SUNDRY NOTICES AND REPORTS ON WELLS
Do not use this form for proposals to drill or to re-enter an abandoned well. Use Form 3160-3 (APD) for such proposals.

8. Well Name and No.
Logos #702H

9. API Well No.
30-043-21219

Logos Operating would like to revise the drilling plan that was submitted with the amended sundry dated 5/14/14. Adjustments are being made to the directional program based on geology. Also note the TMD has been adjusted to 11,250'.

Project: Sandoval County, NM
Site: S8-T22N-R5W
Well: LOGOS #702H
Wellbore: HZ
Design: Plan #9

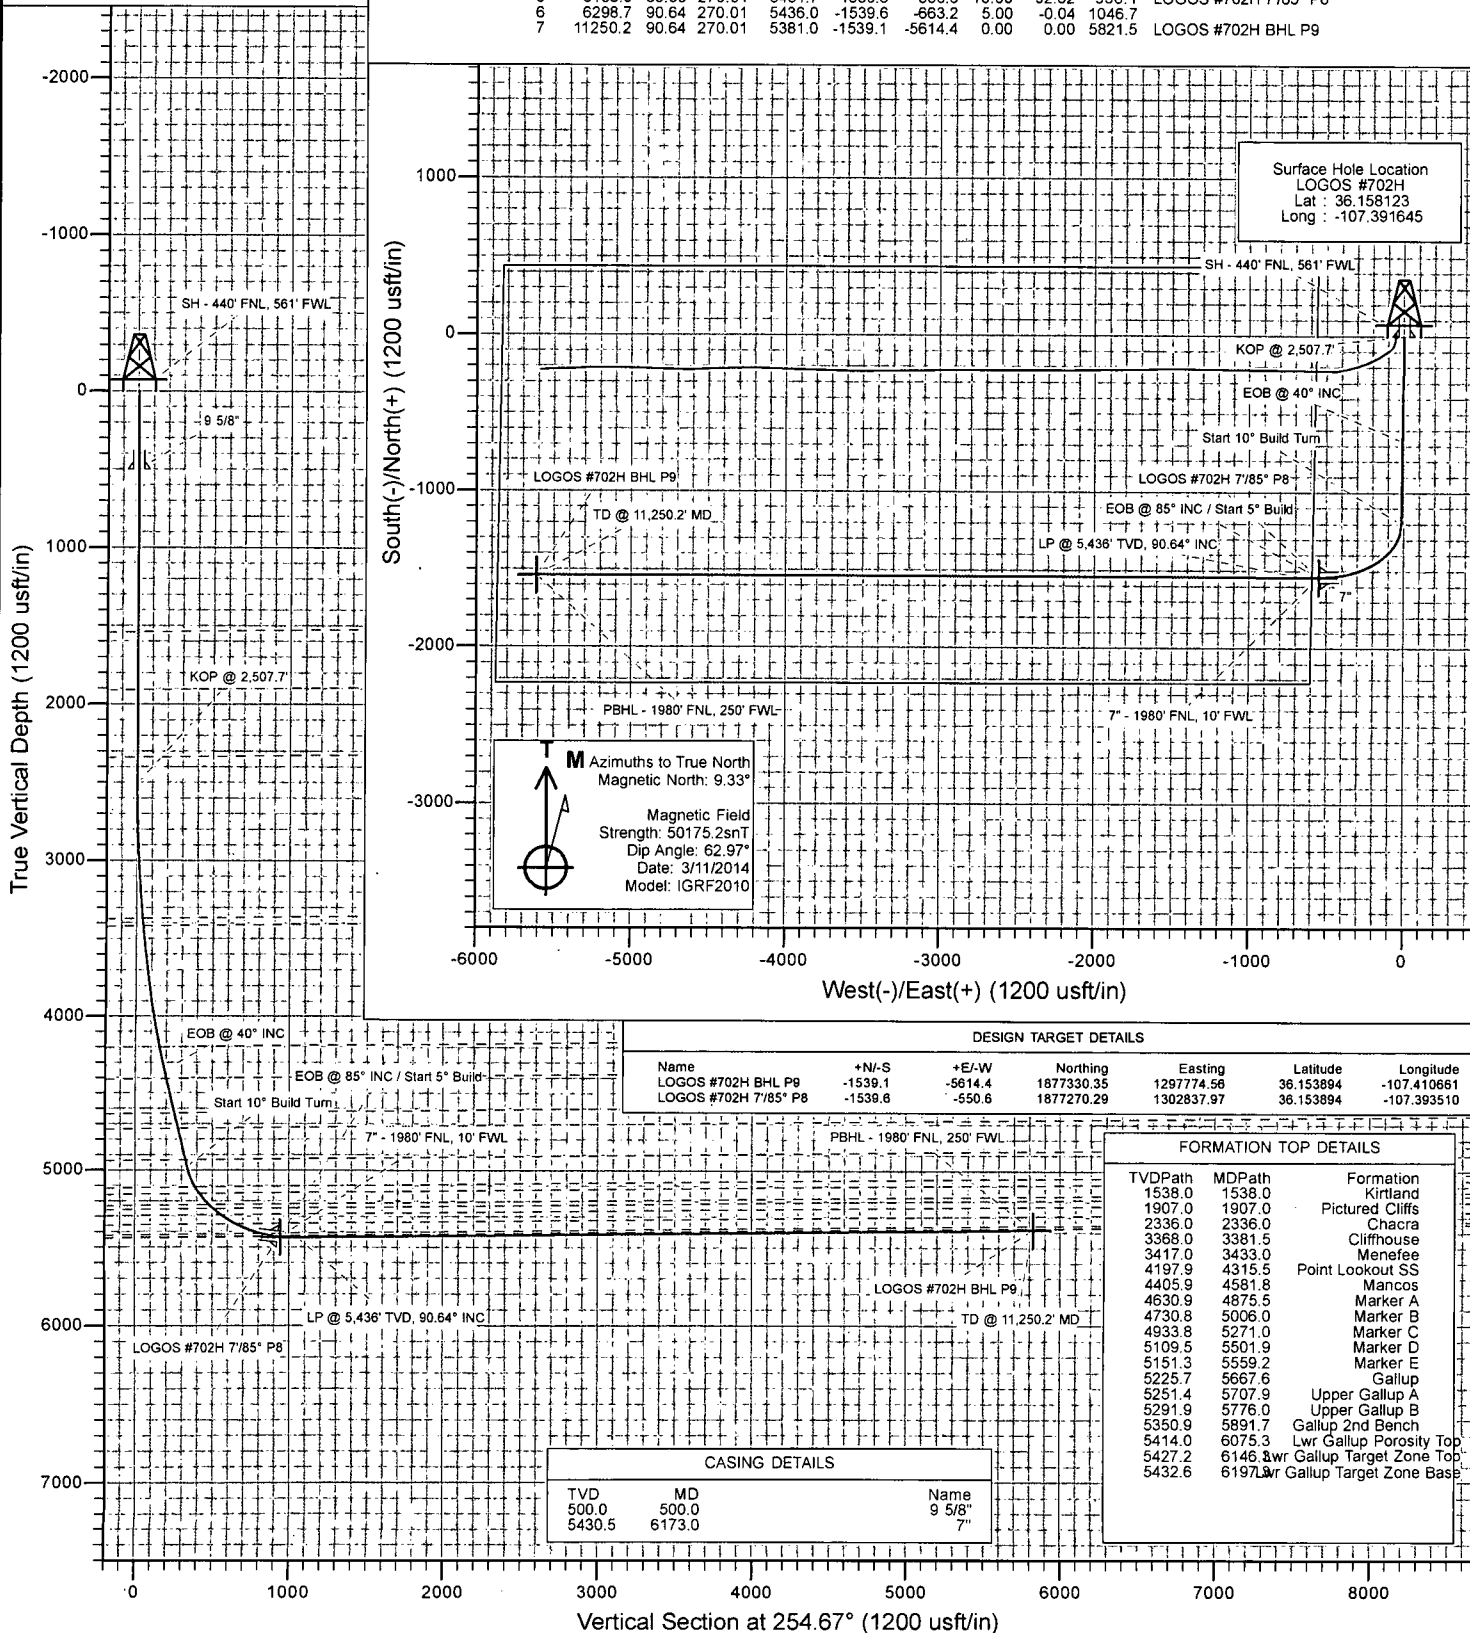
Logos Operating is also revising the bottom hole location from the approved APD footages of 1980' FNL & 330' FWL of Section 7 T22N R05W -to- 1980' FNL & 250' FWL of Section 7 T22N R05W. Based on the following rulings we are going to TD the well at 250' from the FWL, but due to the length of the RSI sleeve the first perf will be greater than 330' FWL. Although this horizontal well will be drilled past the applicable setbacks, an unorthodox location application is not required because the completed interval in this well, as defined by 19.15.16.7 B(1) NMAC, will be entirely within the applicable setbacks. This approach complies with all applicable rules, including 19.15.16.14 A(3) NMAC, 19.15.16.14 B(2) NMAC, 19.15.16.15 B(2) NMAC, and 19.15.16.15 B(4) NMAC.

The Bottom hole location will be in a legal location at 11250' MD at 1980' FNL & 250' FWL of section 7.
